## PRINCE OF WALES DR. DEVELOPMENT

Railway Proximity  
Assessment Review

SYSTRA Canada Reference: 24619-10-GETN-0001\_A

| <input type="checkbox"/> Preliminary/internal verification         | <input type="checkbox"/> Submitted for information | <input checked="" type="checkbox"/> Issued for revision and comments |

Figure 3-1: Vibration Monitoring Points

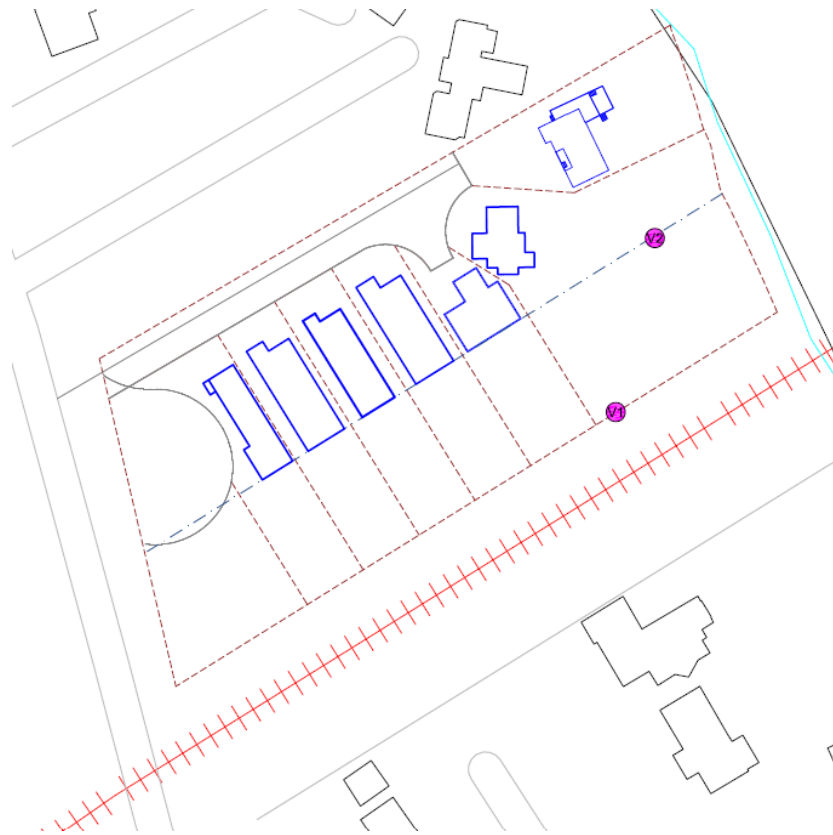
According to the data and the analysis presented in the Transportation Noise and Vibration Assessment, the worst-case measured RMS value for events along the property line were found to be 0.51 mm/s (86 dBV). For events along the 30 m setback line, the worst-case RMS value was found to be 0.14 mm/s (75 dBV). Since measured vibration levels do not exceed the criterion of 0.14 mm/s RMS at the potential foundation of the dwellings, concerns due to vibration impacts on the site are not expected.

Figure 3-2: FCM/RAC’s Standard Noise Mitigation Measure

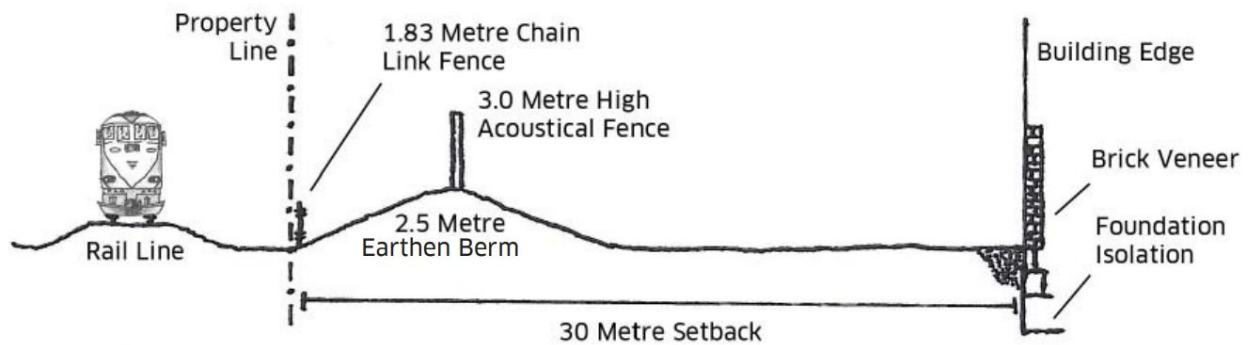
For a standard noise mitigation, FCM/RAC’s Guidelines for New Development in Proximity to Railway Operations recommends a 3-m-high acoustical fence installed on a 2.5-m-tall earthen berm for building having 30-metre set-back from the right-of-way (ROW) line.

Figure 3-5: Receptor's Line of Sight

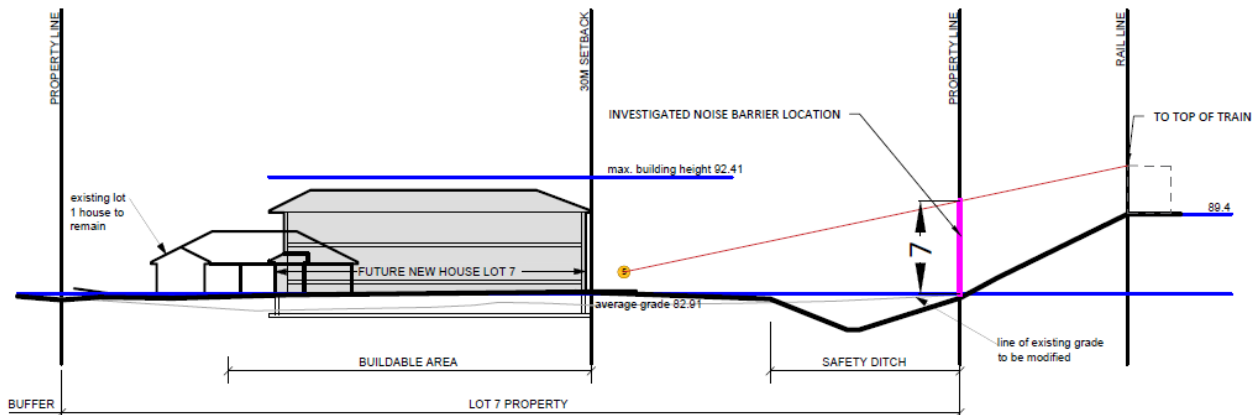
Since the railway track is approximately 6.5 m above the study site’s average grade, it was determined by the Transportation Noise and Vibration Assessment that the implementation of a noise barrier is not considered technically, economically, and administratively feasible for the lots backing onto the VIA Rail corridor, and a Warning Clause will be required in all Lease, Purchase and Sale Agreements.
